MCPB  
ITEM #  
9/21/06

**REVIEW TYPE:** Preliminary Plan of Subdivision, Resubdivision of Lot 6A, Horner Estates

**PROJECT NAME:** Horner Estates

**CASE #:** 120060820

**PRELIMINARY SUBDIVISION PLAN**  
Lots 7 & 8  
**HORNER ESTATES**  
Re-Subdivision of Lot 6  
FIFTH ELECTION DISTRICT - MONTGOMERY COUNTY - MARYLAND

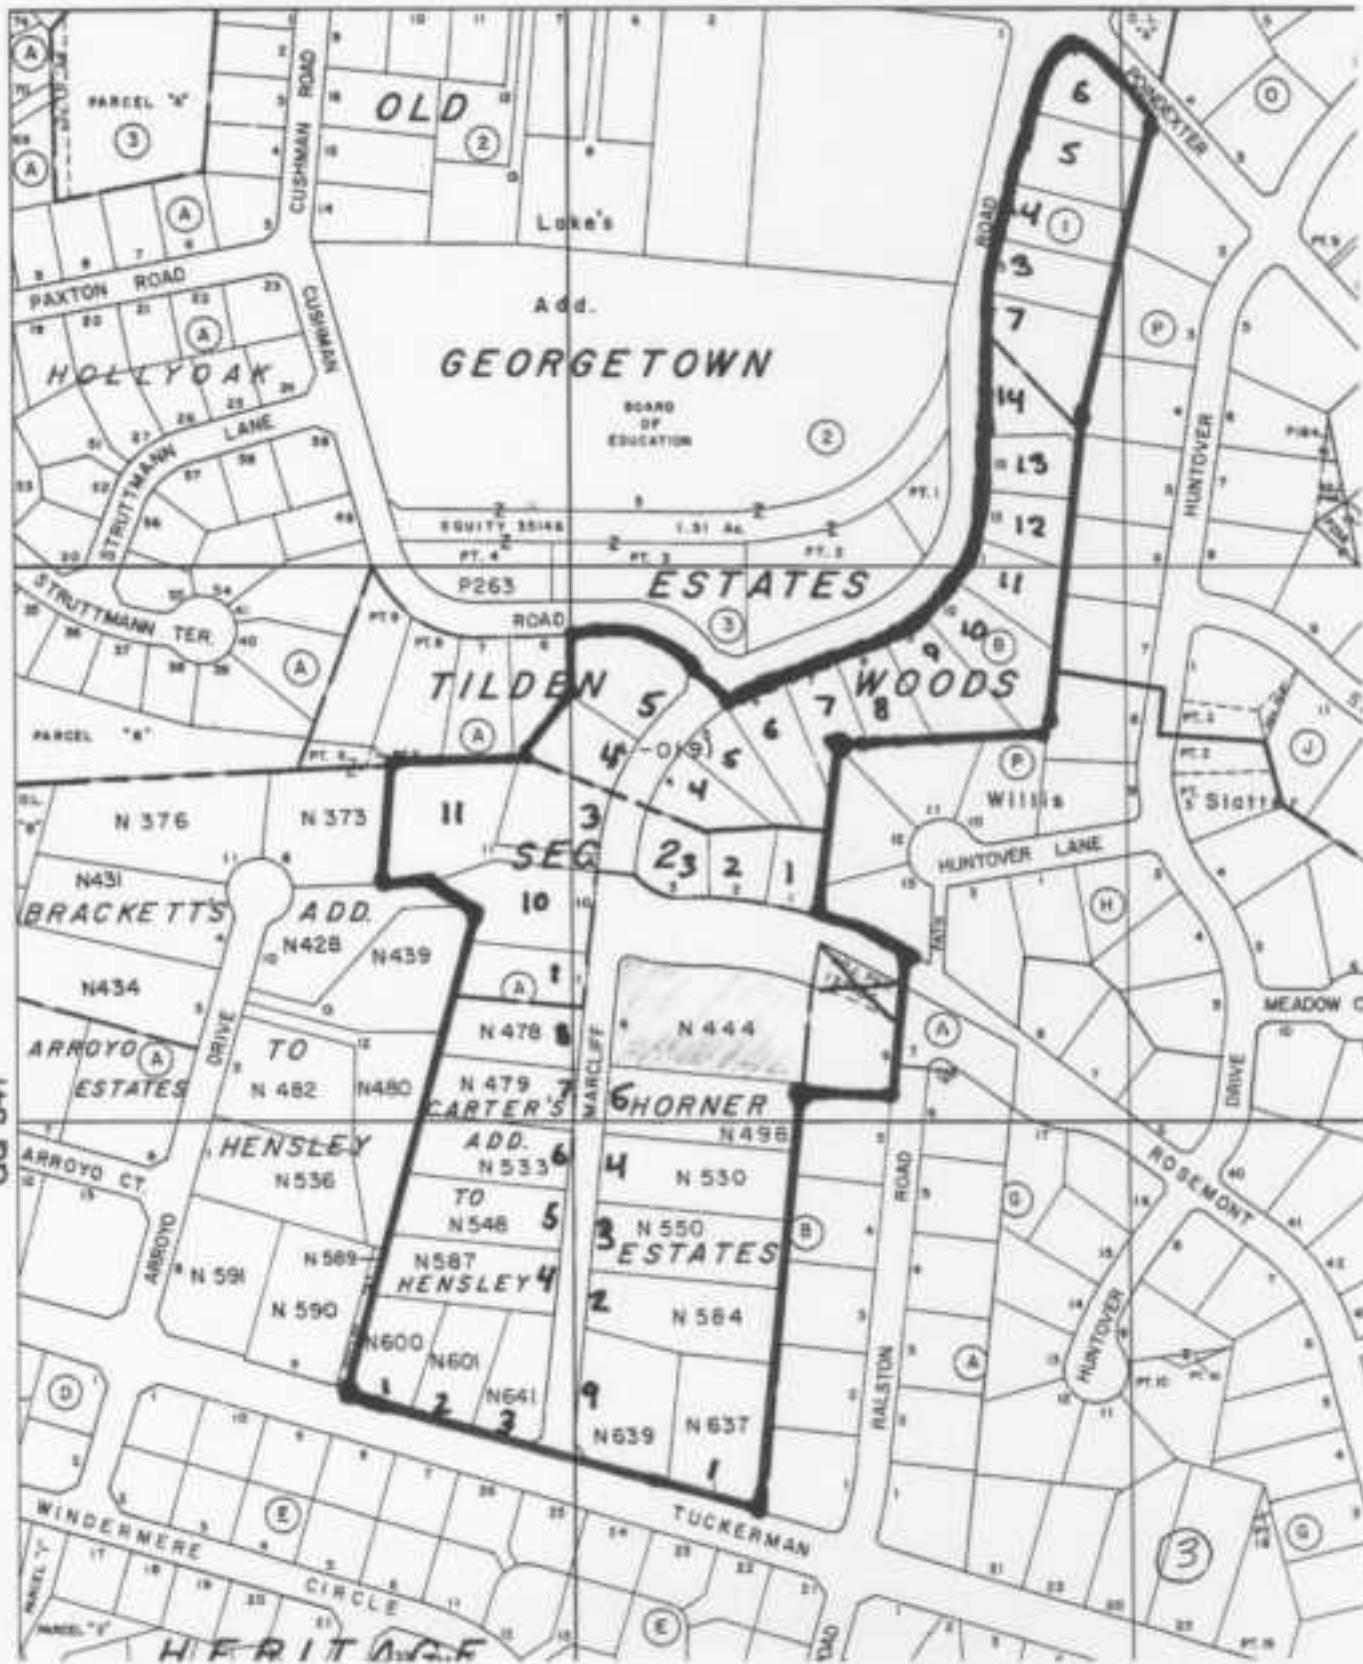
This plan has been reviewed for adequacy of local roadways, access and pedestrian facilities. Marcliff Road is adequate to accommodate the two units as proposed. MCDPWT is requiring sidewalks to provide safe pedestrian circulation. Site distance evaluations for the proposed driveway access point are approved.

There are 0.93 acres of existing forest cover on-site. The plan proposes 0.50-acres of clearing and 0.43-acres of retention within a Category I conservation easement. No forest in the stream valley buffer will be removed. A split rail fence will separate forest conservation area from yard area and signage will be posted at appropriate intervals.

A 10 ft. public utility easement (PUE) is proposed for the north edge of the property, nearest Rosemont Drive. Clearing this PUE will cause separation of the on-site forest from forest on the adjacent right-of-way. Staff will work with the applicant as part of the final forest conservation plan to re-site this PUE, with the utility companies' agreement, to limit forest fragmentation.

The second letter, dated April 3, 2006, implies that the driveway for the proposed homes is being built over a floodplain. The floodplain is delineated on the preliminary plan, and the driveway is separated from it by a minimum of 40 feet and is further located out of the stream valley buffer. A concern was also raised that additional runoff entering the stormdrain from the new homes might cause flooding on a downstream property. A storm drain analysis is required of the applicant by MCDPWT prior to recordation of the record plat. This study will evaluate the capacity of the nearby downstream drainage systems and will require upgrades if necessary. The stormwater management concept approved by MCDPS consists of quality controls using dry wells and sheet flow. Quantity controls are not required because the post development discharge rates for a one-year storm do not exceed the minimum threshold of 2.0 cubic feet per second. The quality controls alone will tend to reduce off site flow. Driveway access permits will be evaluated by MCDPS at the time of building permits, but again, the driveway location shown on the preliminary plan does not directly impact the floodplain.

- 1) Approval under this preliminary plan application is limited to two (2) one-family detached residential lots.
- 2) The applicant shall comply with the conditions of the preliminary forest conservation plan. The applicant shall satisfy all conditions prior to recording of plat(s) or Montgomery County Department of Permitting Services (MCDPS) issuance of sediment and erosion control permit. Conditions include:

- a. Approval of Final Forest Conservation Plan consistent with the approved Preliminary Forest Conservation Plan prior to any clearing, grading or demolition on the site.

- b. The Final Forest Conservation Plan must be prepared, signed and stamped by an ISA certified arborist and include complete details on the proposed tree protection measures.

- c. Split rail fencing and permanent forest conservation signage will be required along the easement line that adjoins residential lots and must be shown on the final FCP.

**PRELIMINARY SUBDIVISION PLAN**  
Lots 7 & 8  
**HORNER ESTATES**  
Re-Subdivision of Lot 8

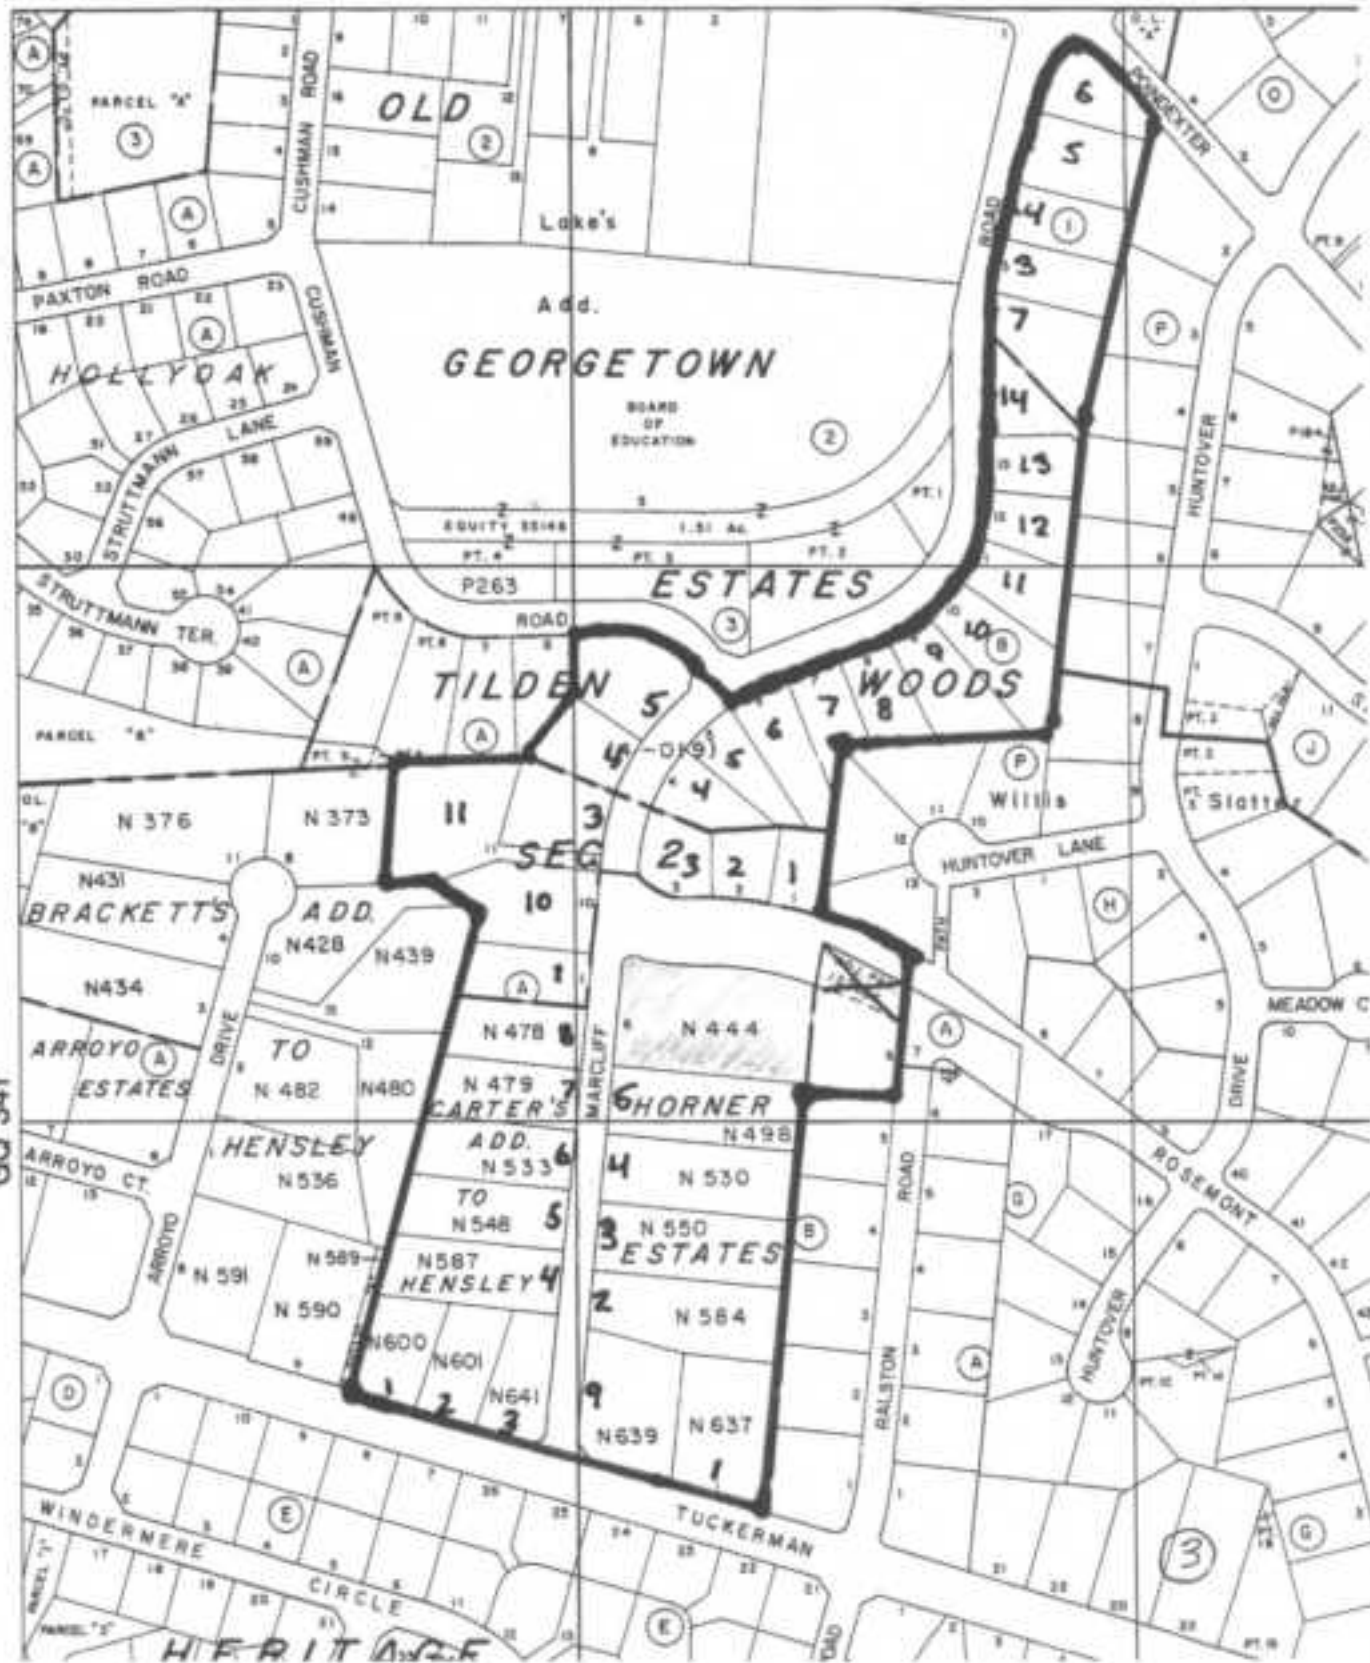
This plan has been reviewed for adequacy of local roadways, access and pedestrian facilities. Marcliff Road is adequate to accommodate the two units as proposed. MCDPWT is requiring sidewalks to provide safe pedestrian circulation. Site distance evaluations for the proposed driveway access point are approved.

There are 0.93 acres of existing forest cover on-site. The plan proposes 0.50-acres of clearing and 0.43-acres of retention within a Category I conservation easement. No forest in the stream valley buffer will be removed. A split rail fence will separate forest conservation area from yard area and signage will be posted at appropriate intervals.

A 10 ft. public utility easement (PUE) is proposed for the north edge of the property, nearest Rosemont Drive. Clearing this PUE will cause separation of the on-site forest from forest on the adjacent right-of-way. Staff will work with the applicant as part of the final forest conservation plan to re-site this PUE, with the utility companies' agreement, to limit forest fragmentation.

The second letter, dated April 3, 2006, implies that the driveway for the proposed homes is being built over a floodplain. The floodplain is delineated on the preliminary plan, and the driveway is separated from it by a minimum of 40 feet and is further located out of the stream valley buffer. A concern was also raised that additional runoff entering the stormdrain from the new homes might cause flooding on a downstream property. A storm drain analysis is required of the applicant by MCDPWT prior to recordation of the record plat. This study will evaluate the capacity of the nearby downstream drainage systems and will require upgrades if necessary. The stormwater management concept approved by MCDPS consists of quality controls using dry wells and sheet flow. Quantity controls are not required because the post development discharge rates for a one-year storm do not exceed the minimum threshold of 2.0 cubic feet per second. The quality controls alone will tend to reduce off site flow. Driveway access permits will be evaluated by MCDPS at the time of building permits, but again, the driveway location shown on the preliminary plan does not directly impact the floodplain.

- 1) Approval under this preliminary plan application is limited to two (2) one-family detached residential lots.
- 2) The applicant shall comply with the conditions of the preliminary forest conservation plan. The applicant shall satisfy all conditions prior to recording of plat(s) or Montgomery County Department of Permitting Services (MCDPS) issuance of sediment and erosion control permit. Conditions include:

- a. Approval of Final Forest Conservation Plan consistent with the approved Preliminary Forest Conservation Plan prior to any clearing, grading or demolition on the site.

- b. The Final Forest Conservation Plan must be prepared, signed and stamped by an ISA certified arborist and include complete details on the proposed tree protection measures.
